Section 3

AN ALTERNATIVE GRAVITY-DOMINATED COLLAPSE SCENARIO

**John B Mander PhD, FIPENZ
Zachry Professor, Texas A&M University**

Figure 3.1. Beam-to-column connection failure sequence at the west wall; a trigger for the East-West Collapse Failure Mode

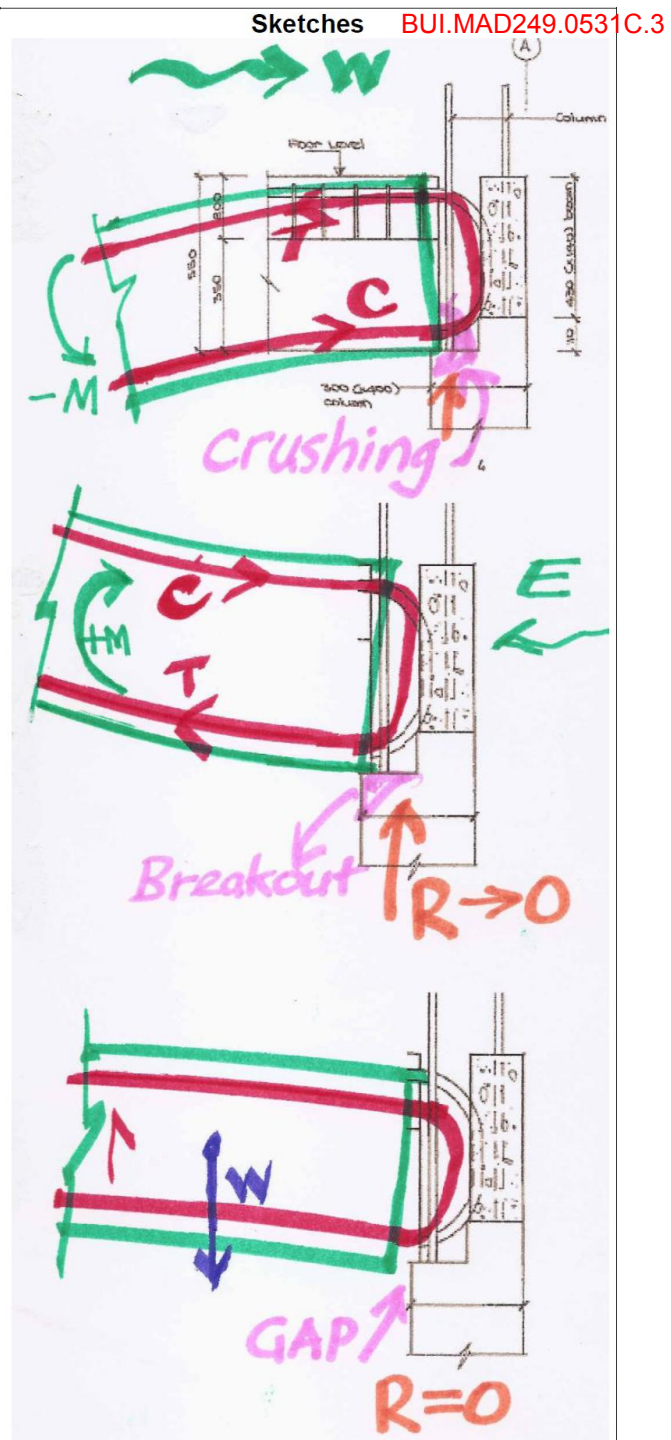
The building sways to the west with a large velocity pulse. The E-W beams on column lines 2 and 3 at the West wall are required to form large negative moments that cause the joint core concrete and the beam-soffit cover concrete to crush.

During the next half-pulse the building lurches eastward. The beam along line 2 and 3 pull away from the west wall and their line A column seats to form the alternating positive moment. The crushed cover concrete from the previous reversal spalls off and the beam slumps down a little, with a partial or full loss of seating. Due to the loss of seating at the support line A there is a transfer of the previous gravity load from the tributary area of the beam onto the neighboring columns on line B. This action an axial force increase of up to 40% the columns along line B

As the building attempts to return to an upright condition by moving west, the unseated beams are inhibited from fully returning due to the presence of the west wall.

Figure 3.2. Four-story double bending buckling failure starting on column Line B leading to the East-West Collapse Failure Mode

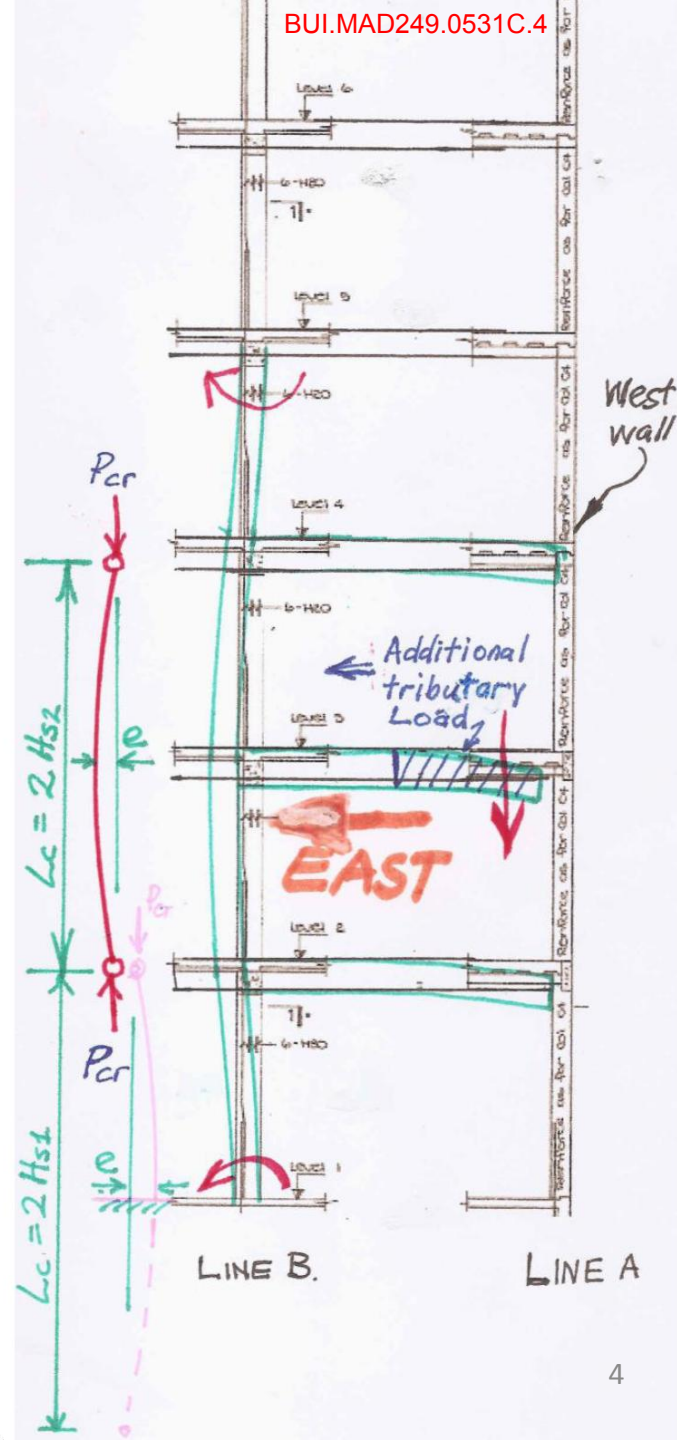
Permanent differential deformations remain, that inhibit the columns along line be from remaining straight. This sets the columns up for a classic Euler buckling type failure, especially under further axial load derived from vertical accelerations and their consequent vibrations

Figure 3.4. North-South Collapse Failure Modes

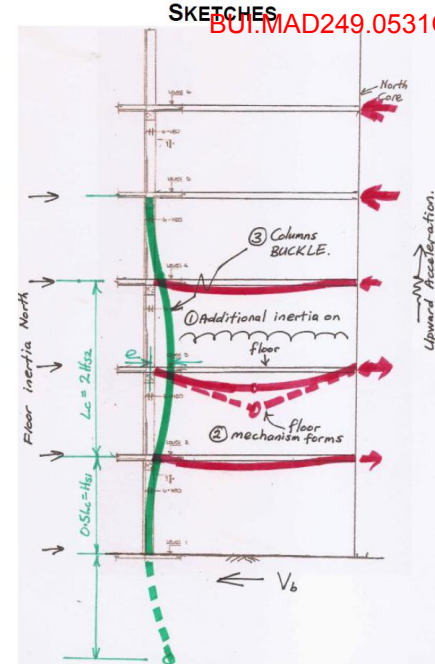
Due to the lack of beams in the N-S direction and very high vertical motions, the in-plane stiffness is low. The slab buckles downward due to a combination of upward vertical acceleration, and N-S sideway of the frame.

Because the slab buckles, and the columns lack lateral support in the N-S direction, a 4-storey, double bending column buckling mechanism forms.

Column buckles and collapses.

Northward Collapse Mechanism

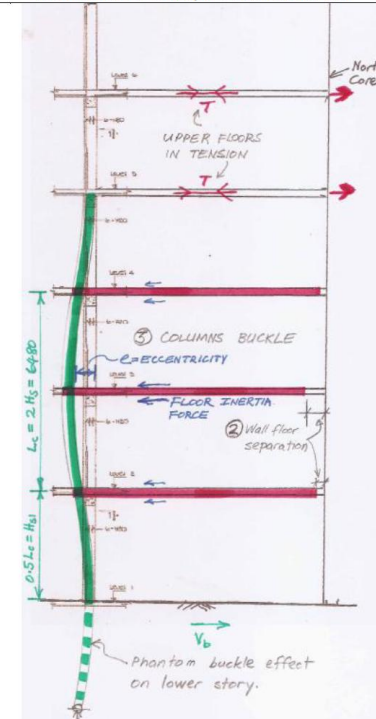
Due to the absence of drag bars in the lower stories, there is a large strain demand placed on the slab steel connecting with the North core. After one or two cycles the bars fracture due to low cycle fatigue.

The columns on lines 2 and 3 lack lateral restraint from moving independently southward, therefore they move away from the north core. A double-bending column buckling mechanism forms in the lower four stories.

Several columns buckle and the structure collapses downward.

Southward Collapse Mechanism

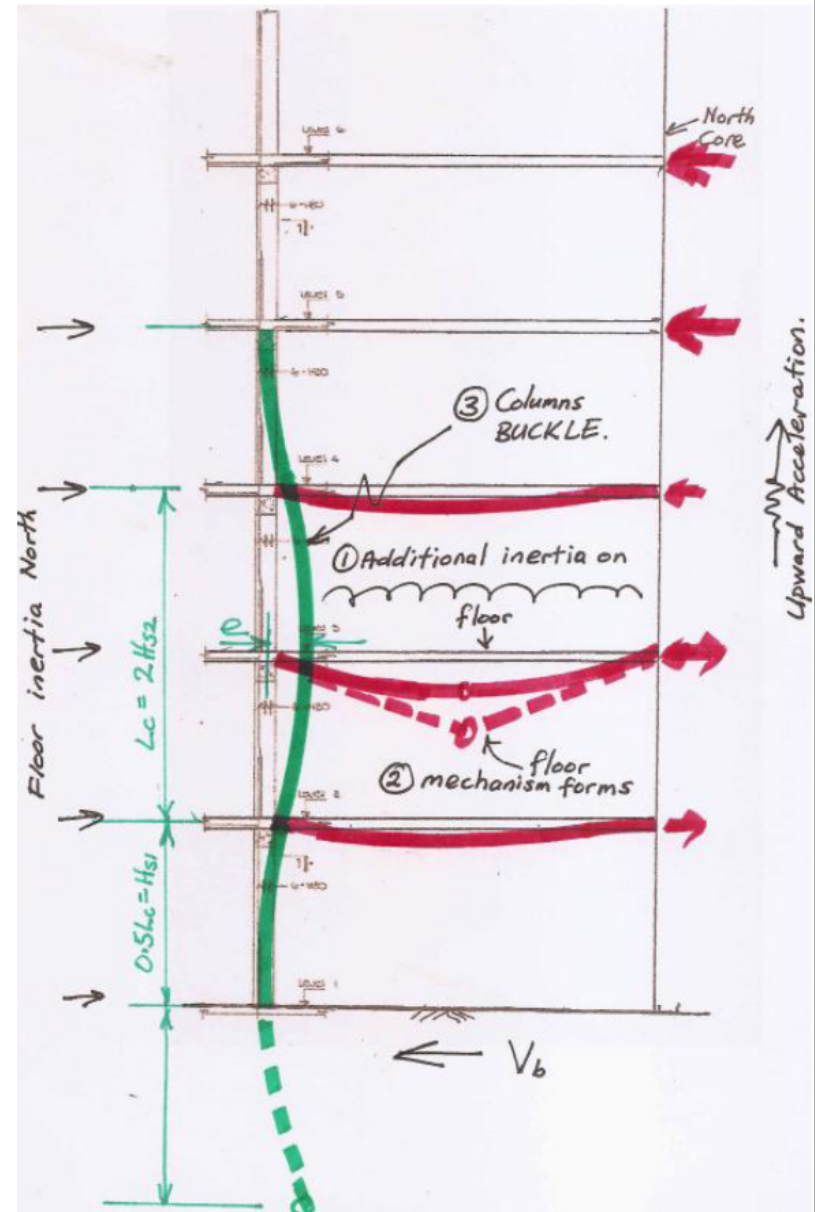
Due to the lack of beams in the N-S direction and very high vertical motions, the in-plane stiffness is low. The slab buckles downward due to a combination of upward vertical acceleration, and N-S sideway of the frame.

Because the slab buckles, and the columns lack lateral support in the N-S direction, a 4-storey, double bending column buckling mechanism forms.

Column buckles and collapses.

Northward Collapse Mechanism 7

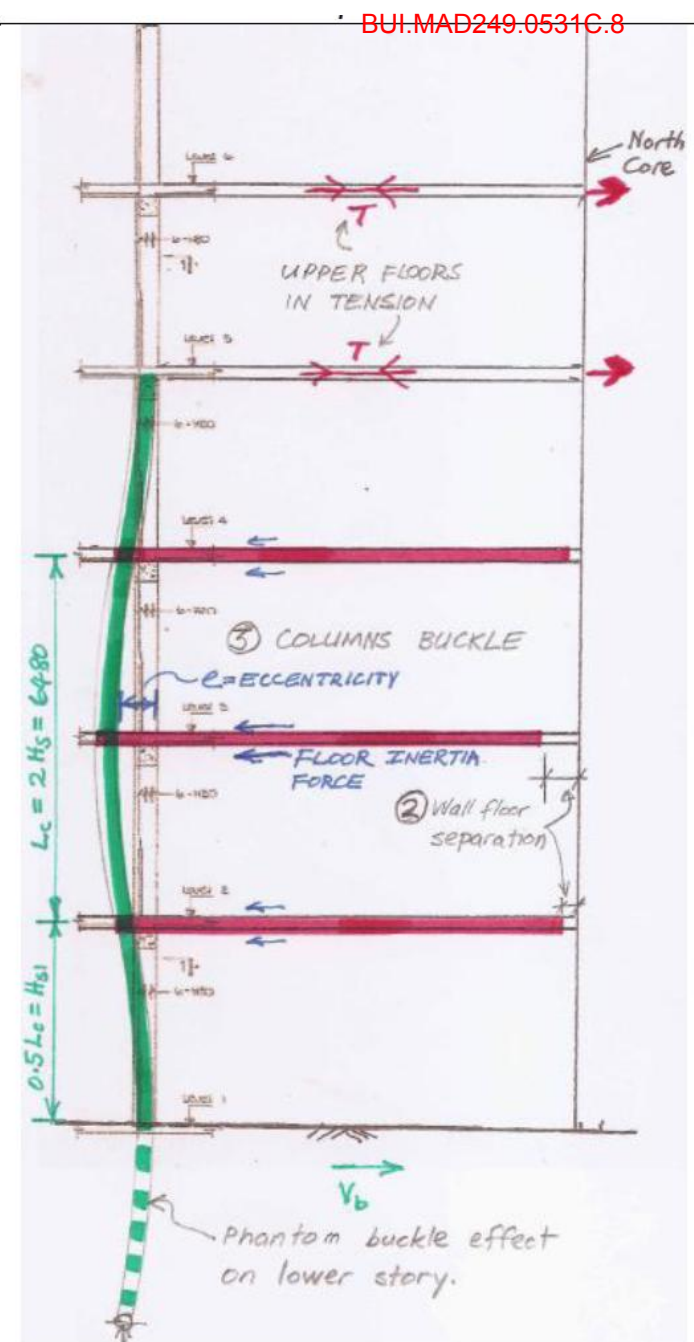
Due to the absence of drag bars in the lower stories, there is a large strain demand placed on the slab steel connecting with the North core. After one or two cycles the bars fracture due to low cycle fatigue.

The columns on lines 2 and 3 lack lateral restraint from moving independently southward, therefore they move away from the north core. A double-bending column buckling mechanism forms in the lower four stories.

Several columns buckle and the structure collapses downward.
